HOLDOVER

Revised

JOE MILLER SUBDIVISION

APPLICATION NUMBER Holdover DATE August 5, 2004
APPLICANT Joe Miller Subdivision
REQUEST Subdivision

JOE MILLER SUBDIVISION

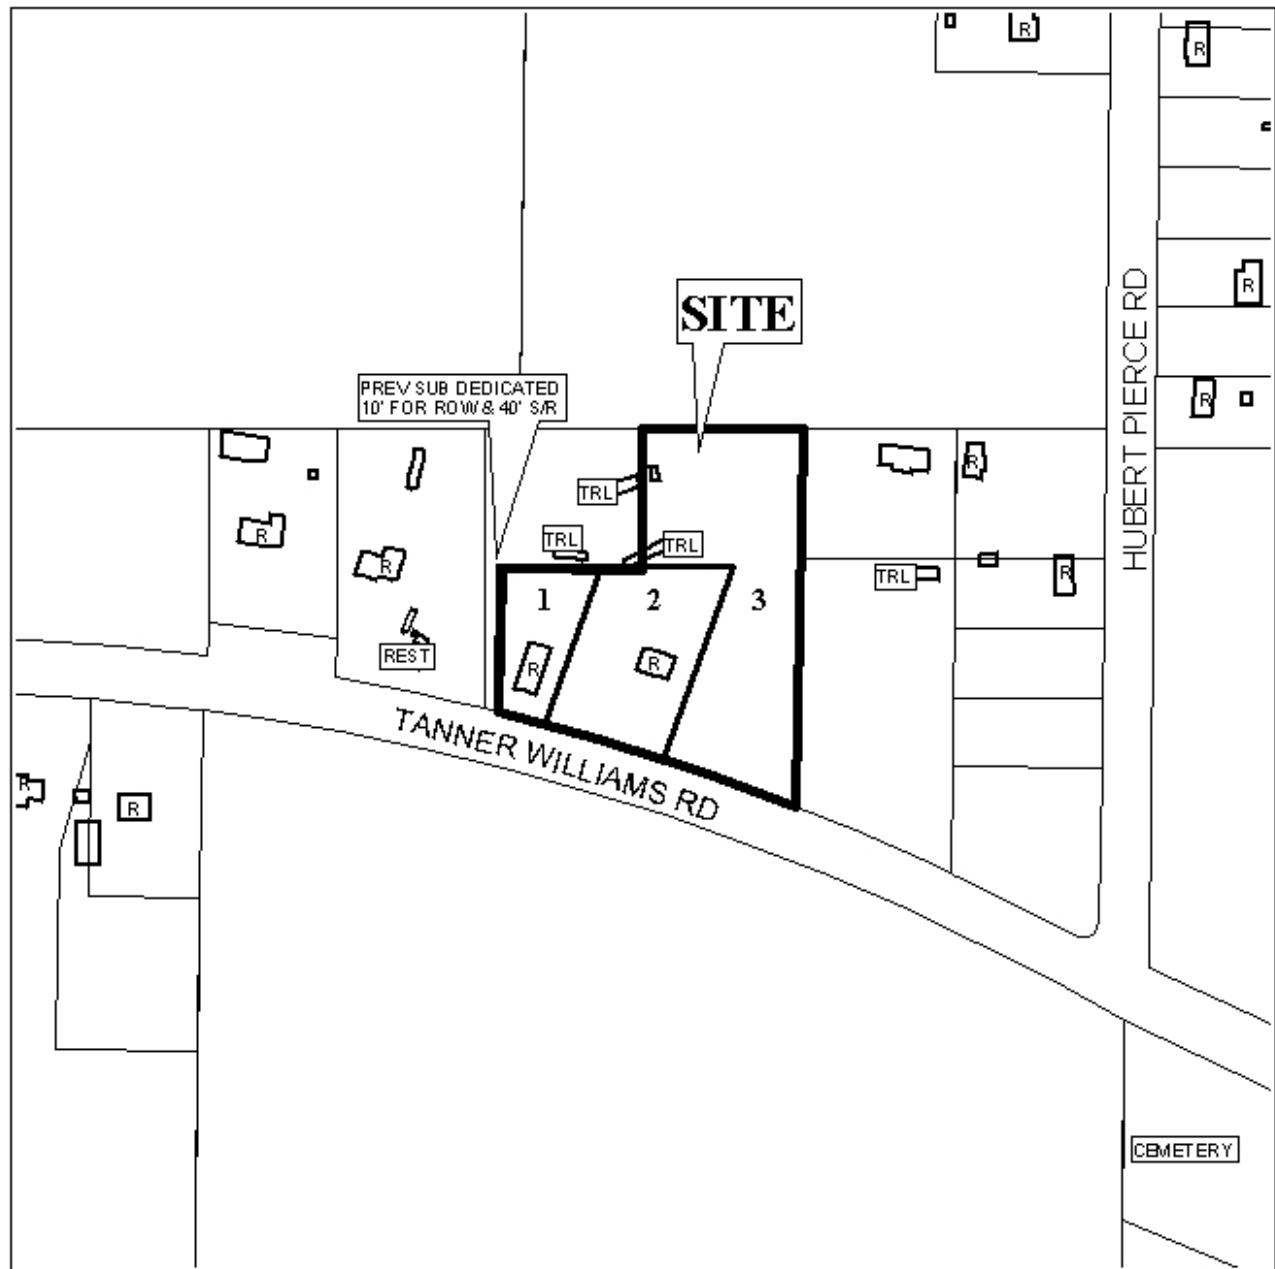
The 25-foot minimum building setback lines are not shown but would be required on the final plat.

The plat does not illustrate the balance of the property from which the three lots are being taken. The balance of the parcel should be included in the subdivision or the submission of documentation to establish the parcel as a legal lot of record prior to 1984, should be required.

The original report inadvertently omitted the fact that Tanner Williams Road is a Planned Major Street, and as such requires a minimum right-of-way of 100' and either a 40' parallel service road or an alternative method of access management.

The flag shaped lot immediately adjacent to the West and the property approximately 200' West of that have dedicated additional right-of-way for widening and for a parallel service road.

The plat meets the minimum requirements of the Subdivision Regulations and is recommended for Tentative Approval subject to the following conditions: 1) the placement of a note on the final plat stating that any lots which are developed commercially and adjoin residentially developed property must provide a buffer, in compliance with Section V.A.7. of the Subdivision Regulations; and the placement of the 25-foot minimum setback lines on the final plat; and 2) placement of a 75' setback from centerline of Tanner Williams Road to allow for the planned major street.
